Designtex Knitwear Ltd (New Building)

Beraiderchala, Sreepur, Gazipur.
(24.193070, 90.416069)
10th June & 25th Aug 2021

Observations

Load combinations

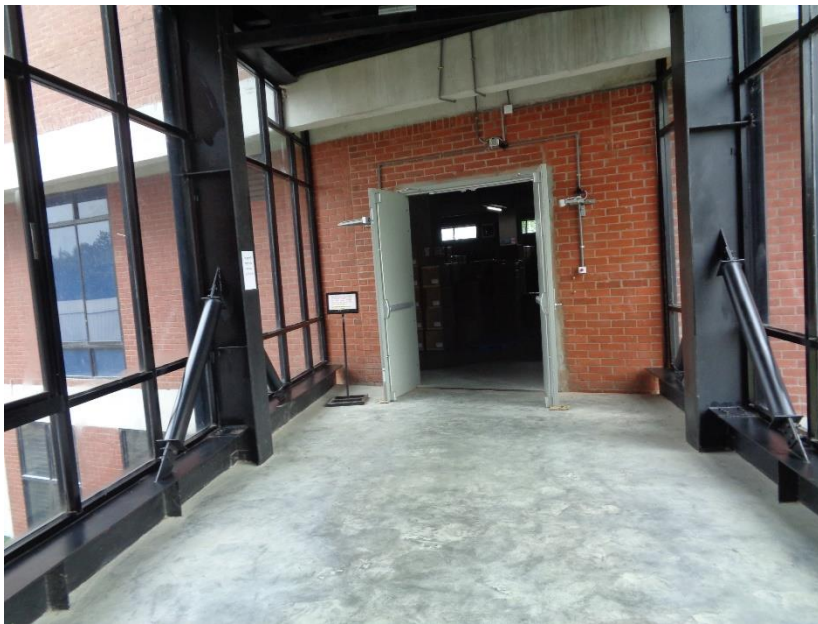
Prepared Design Report to be updated

A Design Report is prepared including design parameters for wind and seismic loads. All the load combinations from BNBC part-6 are not considered in Design Report. Also, stability checks are not included in this report. Factory engineer is required to include all load combinations, stability check for all structural members and update the Design Report in compliance with the BNBC (section 1.9.1 of part-6).

Item No.	Observation	Recommended Action Plan	Recommended Timeline
01	Prepared Design Report to be updated (Warehouse Building)	Factory engineer is required to update the Design Report in compliance with the section 1.9.1 of BNBC part-6.	6-weeks
02	Prepared Design Report to be updated (Warehouse Building)	Implement remediation as outcome of Design Report (if required).	6-months
03	Load plan to be produced (Connecting Bridge)	Factory is required to produce floor live load plan as per design documents.	6-weeks
04	Load plan to be produced (Connecting Bridge)	Implement the floor load plan.	6-months
